## Preliminary Plan 4-12011

STAFF REPORT

SUBJECT: Preliminary Plan of Subdivision 4-12011  
Strayer University  
Parcels A and B

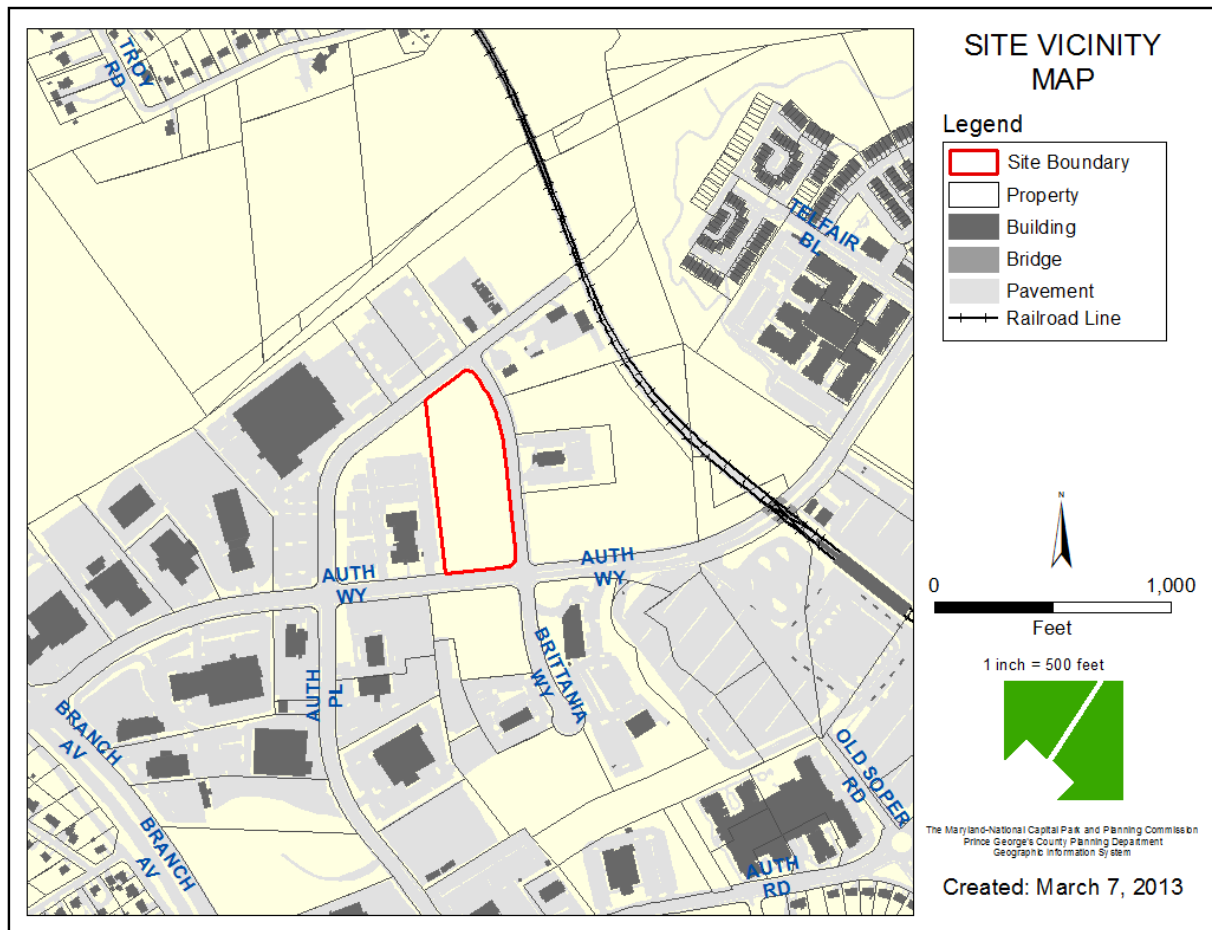
The property is subject to the provisions of the Woodland and Wildlife Habitat Conservation Ordinance (WCO) because the gross tract area is greater than 40,000 square feet in size and the property contains more than 10,000 square feet of woodland. A Type 1 Tree Conservation Plan (TCP1-024-00-01) was submitted with the review package and shows a different woodland acreage from the NRI. The NRI states that the 5.43-acre site is entirely wooded with 5.43 acres; however, the submitted TCP1 states that the site contains 5.22 acres of woodlands. Based on current aerial photography taken from PGAtlas, the site is entirely wooded, and it appears that the NRI is more consistent with the correct acreage. The TCP1 should be revised to reflect the correct on-site woodlands.

The TCP1 does not show all of the ten required TCP1 notes and does not use the standard language provided in the Environmental Technical Manual (ETM). Notes 7–10 are not shown on the plan. The plan should be revised to correctly show all of the TCP1 notes as noted in the ETM using the appropriate plan number and applicable notes.

Other technical revisions are required. The plan needs to add the approved stormwater management concept plan number to Note 8; show the legend on Sheet 2 on the plan view sheet; the specimen tree chart needs to add one informational column to the chart; revise the M-NCPPC approval block on the plan to read “TCP1-024-00-01”; and include in the approval block in the “approved by” initial block PGCPB Resolution No. 00-218 and date, November 30, 2000.

1. Prior to signature approval of the preliminary plan of subdivision, the following technical corrections shall be made:
  - a. Revise Note 34 to: “The subject property is located within the Imaginary Surfaces area of Interim Land Use Control (ILUC). This property is within the area establishing a limit on the height of structures. The property is within Imaginary Surface E, and is located 5,948 feet from the end of the west runway. This location and distance establish a height limit of 447.4 feet above the elevation of the runways, which are 250 feet above sea level. Therefore, the maximum elevation of the building may not exceed 697.4 feet above sea level. At the location of the present application, the elevation is 246 feet above sea level at its highest point. The building may not exceed 451.4 feet in height.”

- b. Revise Note 16 to correct the tree conservation plan number to “TCP1-024-00-01.”
  - c. Revise Note 29 to: “Number of Parcels: Existing-1, Proposed-2.”

2. Prior to signature approval of the preliminary plan of subdivision, the Type 1 tree conservation plan (TCP1) shall be revised as follows:
  - a. The TCP1 must be revised to match the natural resources inventory correct woodland acreage.

- b. Revise the plan to correctly show all of the TCP1 notes as noted in the Environmental Technical Manual using the appropriate plan number and applicable notes. Specifically, add the notes regarding the roadway designations.

- c. Remove “Beech Tree” from required Note 7.
  - d. Add the stormwater management concept plan number to Note 9.
  - e. Revise the specimen tree chart to add one column “Retain/Remove.”

- f. Revise the approval block to include the Type 1 Tree Conservation Plan, TCP1-024-00-01.
  - g. Include in the approval block in the “approved by” initial block PGCPB Resolution No. 00-218 and date, November 30, 2000.
  - h. Have the revised plan signed and dated by the qualified professional who prepared it.
  - i. Provide the gross floor area of the building, including dimensions.
3. Prior to signature approval of the preliminary plan of subdivision, the applicant shall obtain certification of previously approved Conceptual Site Plan CSP-00022.
4. Development of this subdivision shall be in conformance with an approved Type 1 Tree Conservation Plan (TCP1-024-00-01). The following note shall be placed on the final plat of subdivision:
